Proposal #05: 6020-04-72, WISC 2024061
Deforest – Portage
Tomlinson Rd to Ontario St
USH 51
Columbia County

This is Addendum No. 02, which provides for the following:

ADDENDUM NO. 02

6020-04-72

Addendum No. 02
ID 6020-04-72
Revised Sheet 2
March 7, 2024

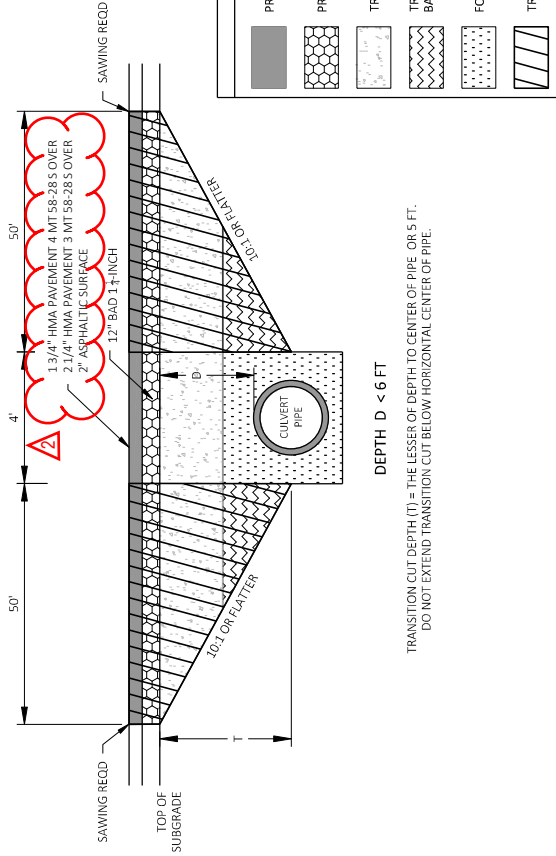
Revised Plan Sheets	
Plan Sheet	Plan Sheet Title (brief description of changes to sheet)
2	Revised HMA pavement table
14	Revised lifts on construction detail
53	Revised callout to proper HMA thickness
71	Revised callout to proper HMA thickness and lift thickness
75	Revised callout to proper HMA thickness and lift thickness
108	Revised quantity for Asphaltic Surface
109	Revised quantity for HMA Pavement 3 MT 58-28 S
110	Revised PWL Table
115	Revised items for Traffic Control

PAVEMENT LOCATION	TOTAL PAVEMENT THICKNESS	LAYER	TYPE
USH 51 URBAN AND MAJOR INTERSECTIONS	5-INCHES	1.75-INCH UPPER	4 MT 58-28 S
USH 51 RURAL	4-INCHES	3.25-INCH LOWER	3 MT 58-28 S
		1.75-INCH UPPER	4 MT 58-28 S
USH 51 FULL DEPTH REPLACEMENT AT RAILROAD CROSSINGS	7.5-INCHES	2.25-INCH LOWER	3 MT 58-28 S
		1.75-INCH UPPER	4 MT 58-28 S
		3.25-INCH LOWER	3 MT 58-28 S
		2.5-INCH LOWER	ASPHALTIC SURFACE

Addendum No. 02
ID 6020-04-72
Added Sheet 198A
March 7, 2024

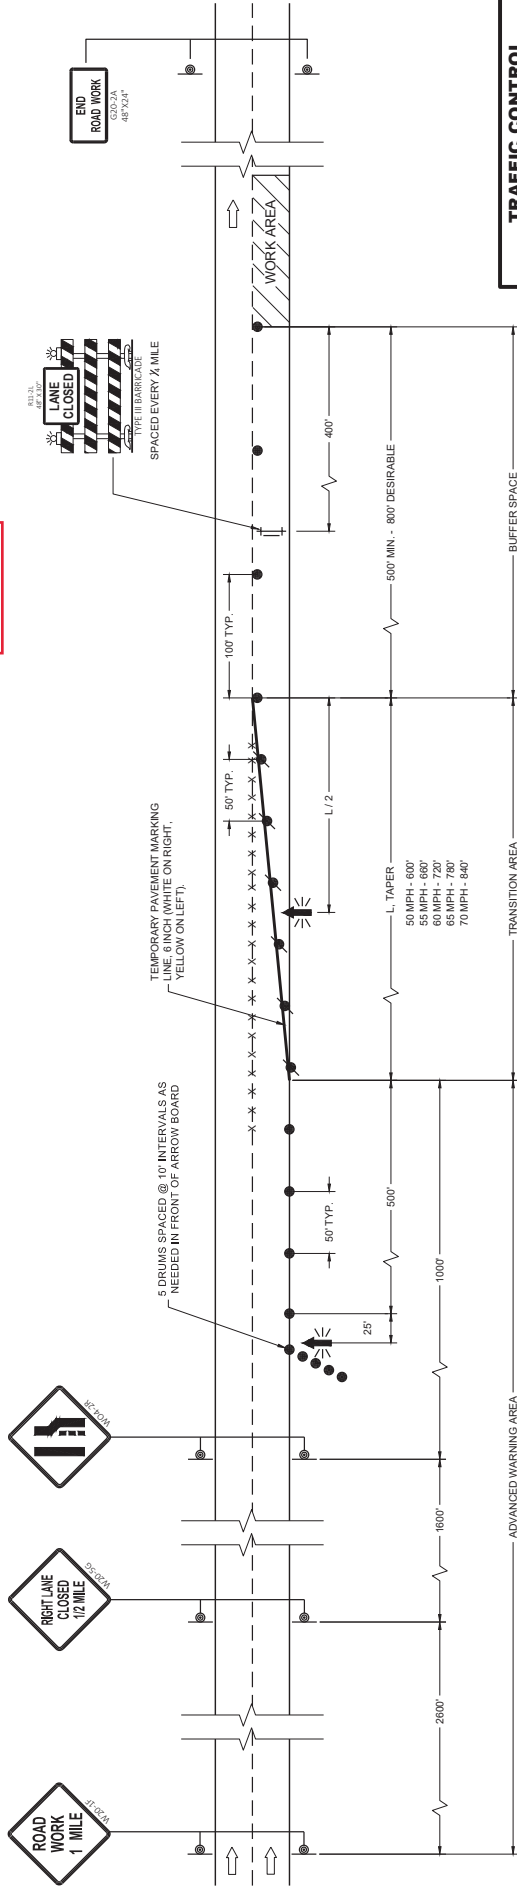
Added Plan Sheets	
Plan Sheet	Plan Sheet Title (brief description of why sheet was added)
198A	SDD 15D12-12a, Traffic Control Lane Closure
